Feb27 – Mar6

Multi-layer fabrication investigation

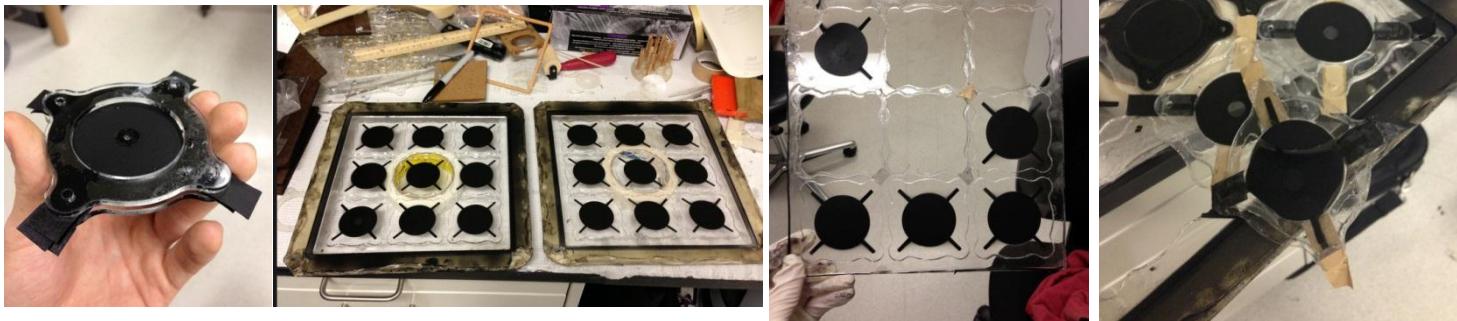
Comment:
That's a good thing
to reduce failure rate
of fabrication

Can be a good way for stretched acrylic film manipulation.

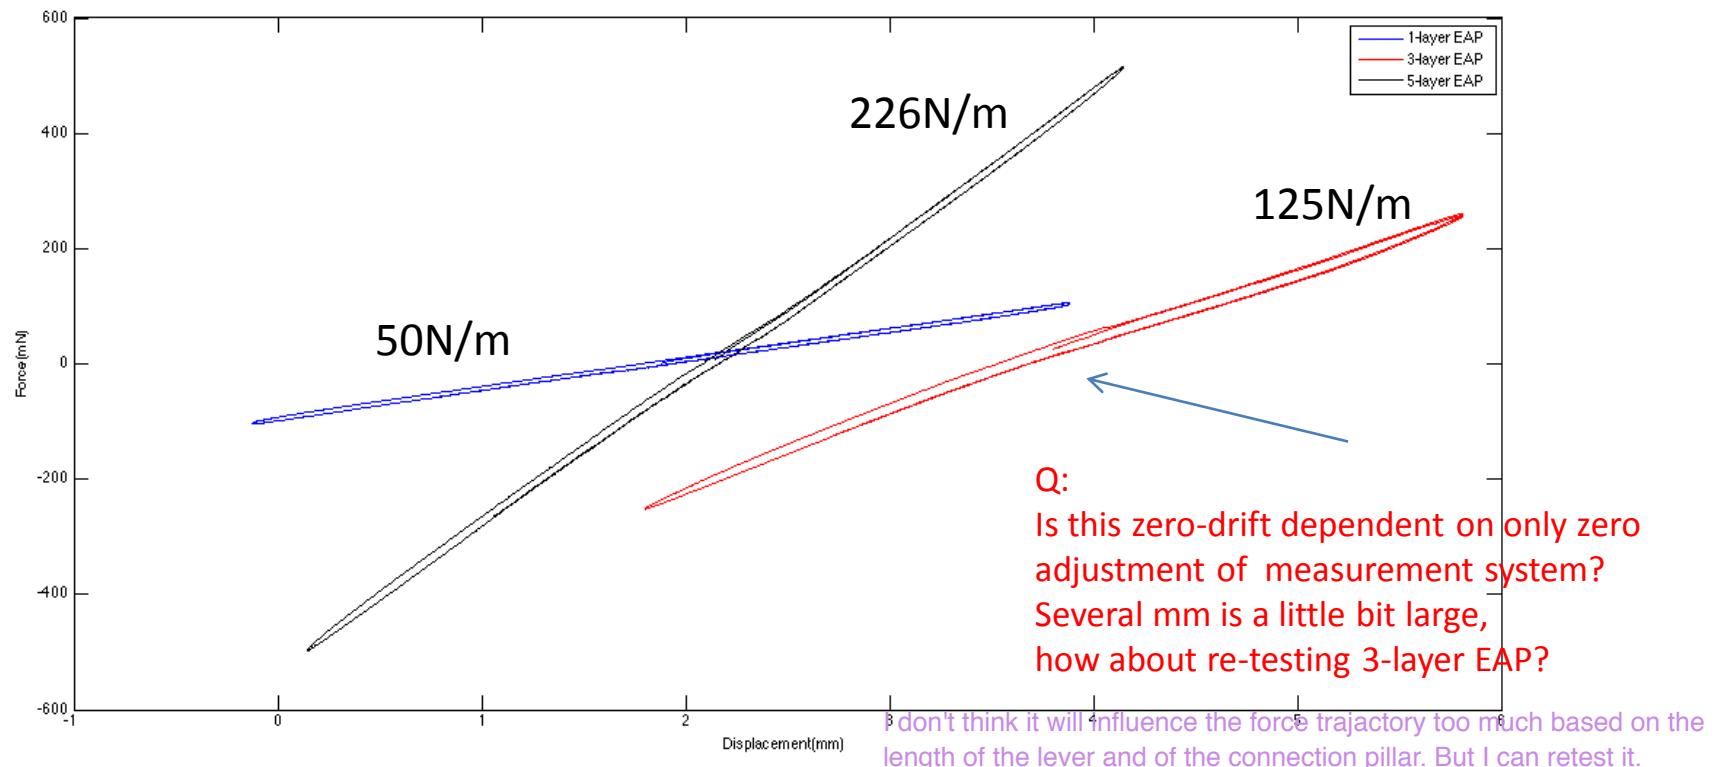
**Suggestion: How about using Electrolytic copper foil(0.009mm thickness)
As adhesive tape,**

I found a product ([copper adhesive tape example](#)). Please check it.

Thanks for the suggestion. It is good it thickness is so small. But it also says the overall thickness is 0.03mm, but actually still good enough.

Hysteresis of 5-layer EAP under different frequencies:

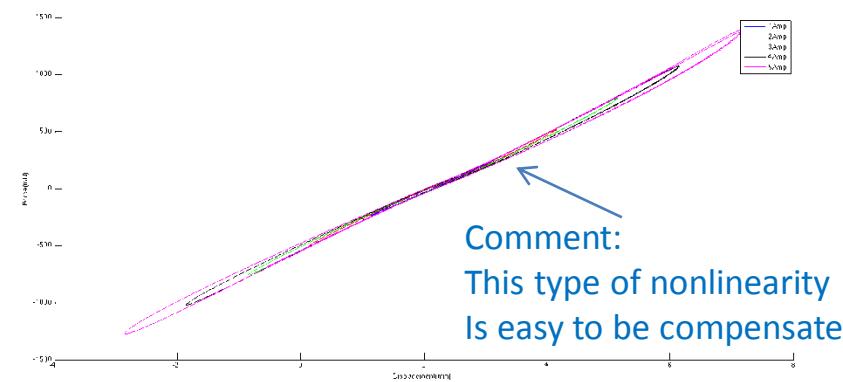
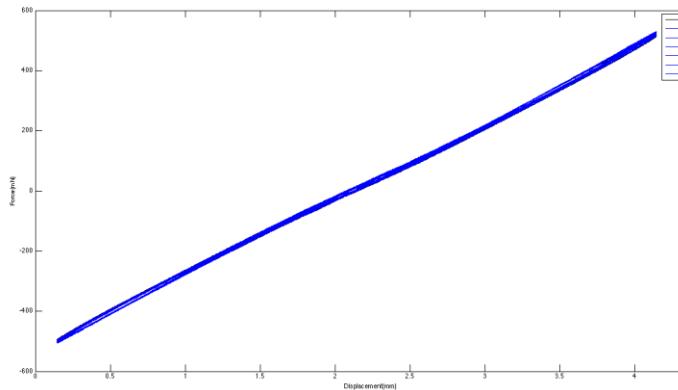
How large the range of frequency
In this experiment?

Comment:
This type of nonlinearity
Is easy to be compensated

It is from 0.4 to 2 Hz. I will test with higher
frequencies in this week.

Actuated 5-layer EAP: [Attach:Plot_actuated_tests_Mar5.png](#)

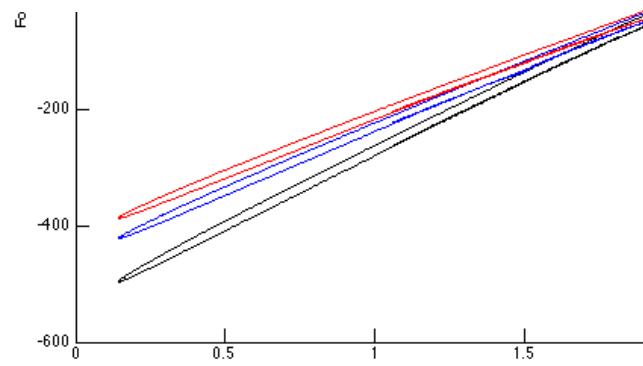
It might be possible to release pre-strain in multiple-layer fabrication.

According to force/strain character of raw EAP film, this device might need more voltage .

1. Please check whether measuring device works correctly.
2. Please re-testing this.
3. If the result is same to previous one, how about testing 3-Layer EAP?
And in experiment measuring electrical current helps you to guess whether all of the layer are charged or not.

The stiffness range is small, which is because of:

- 1) one of the layer doesn't work because of lack of conductive tape.
- 2) no electrical connection strengthen between two adjacent layers.
- 3) short occurred because of acrylic sheet contamination during fabrication and cannot actually generate the input voltage
(the plot legend is for input voltage, not actual value)
